# Conceptual Review Agenda

# Rigden Farm Commercial Mixed-Use

**Re: Rigden Farm - Commercial Mixed-Use**

**Re:** 1303 SW Frontage - Outdoor Storage

# W.F.C.U

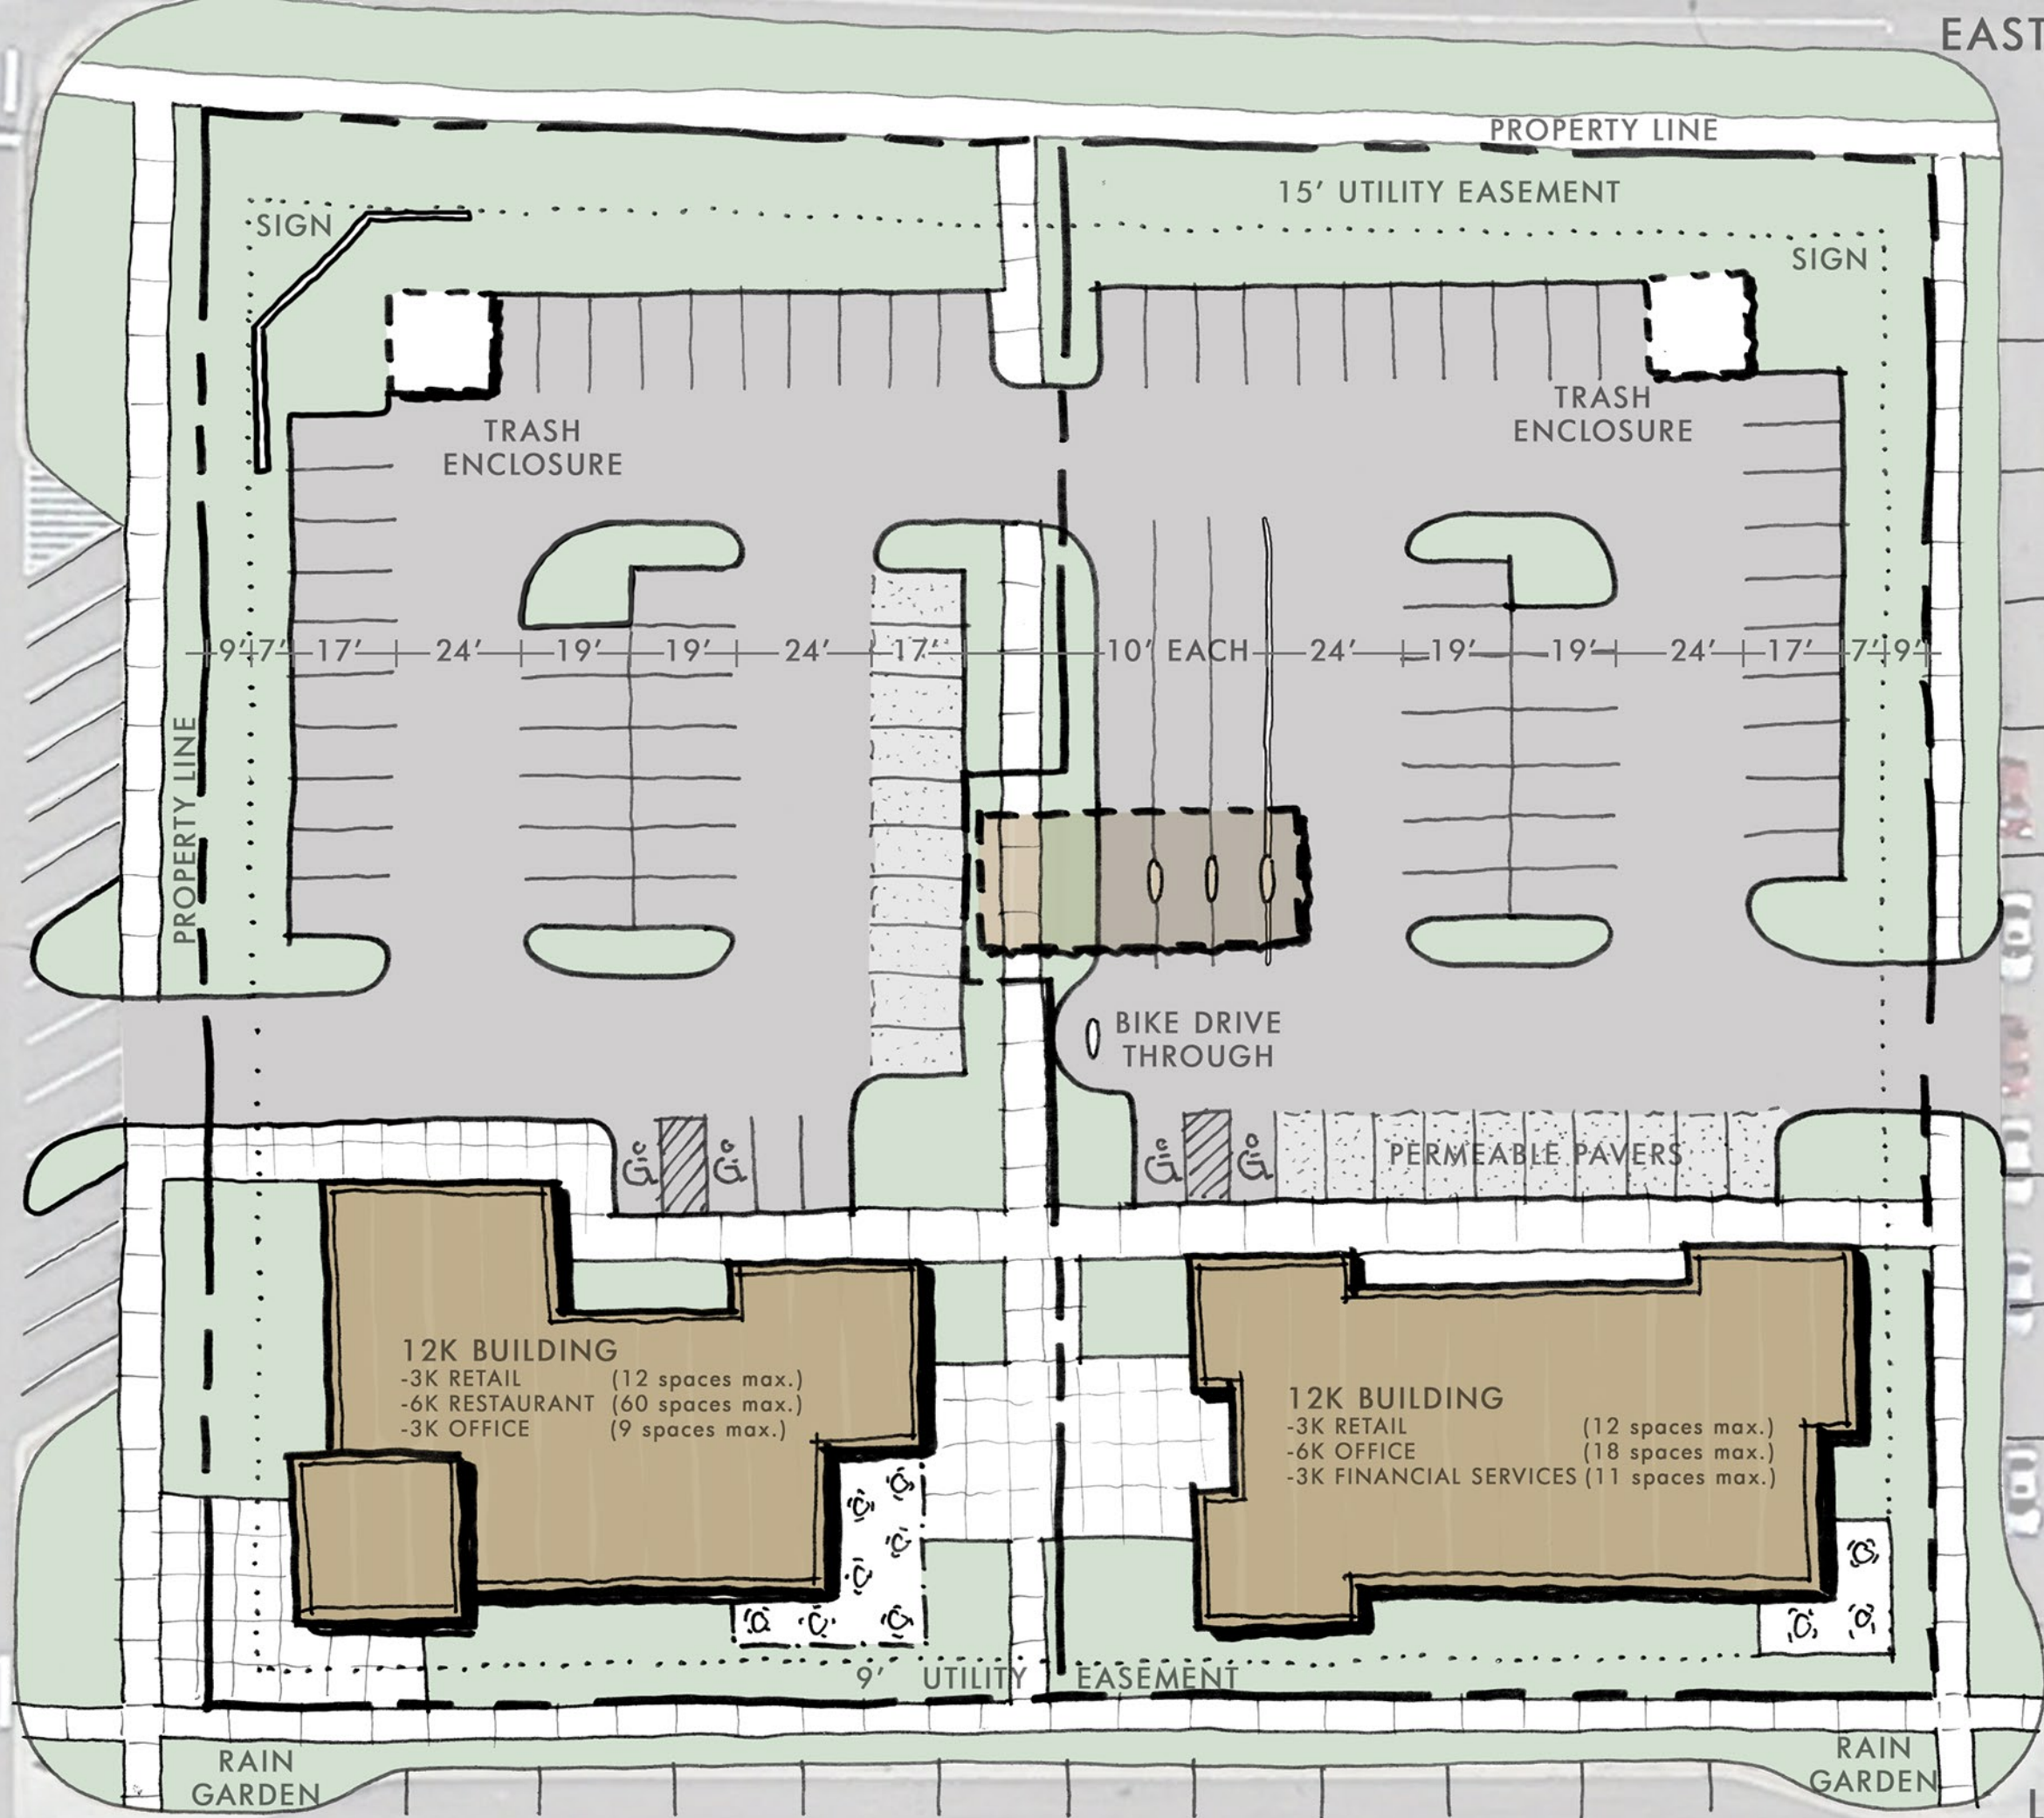
3. The trash enclosures seem to be a long distance from the building. For both practicality and logistics consider placing these more to the center of the lot. There are limits to distances these can be from a public sidewalk.

11. Access location will need to meet spacing requirements. An access location out to Illinois can be done, more parking than you have shown on your plan will be eliminated due to the need setbacks to the access point and the curb design that allows for street sweeper access. We will need to work with traffic operations regarding the spacing needs for parking and driveway separation. Likely an additional street inlet will need to be installed to collect the drainage in the parking.

The buildings should align with previously established building and sidewalk relationships and located on the corners of the property anticipated to have the greatest pedestrian traffic. If the building on the southeast corner of the site could be moved to the corner of Illinois and Drake, it would fit the "Main Street"-style pattern of development along Illinois. Alternatively, you could explore dedicating additional ROW to provide diagonal parking on Limon instead of Illinois.

3. This proposal shows a good framework of connecting walkways. I appreciate the connections around all sides of the buildings and to adjacent properties, as well as the gathering space between the buildings. For areas where pedestrians are forced to cross drive aisles or parking lot entrances, consider using special paving or other treatments to clearly delineate crossing areas.

5. Bicycle parking requirements will need to be met, per LUC section 3.2.2(C)(4). Based on what is shown on the plan, a minimum of 18 bicycle parking space need to be provided. At least 3 of these would need to be enclosed, and the remainder could be provided as fixed racks. Bicycle parking should be located in areas that are visible and convenient to building entrances.

6. The calculations and amount of parking shown on the plan are consistent with the LUC standards. Please note that new parking minimums for commercial development were recently adopted by City Council, and the Land Use Code will soon be updated to include those. This is not likely to be an issue for this project.
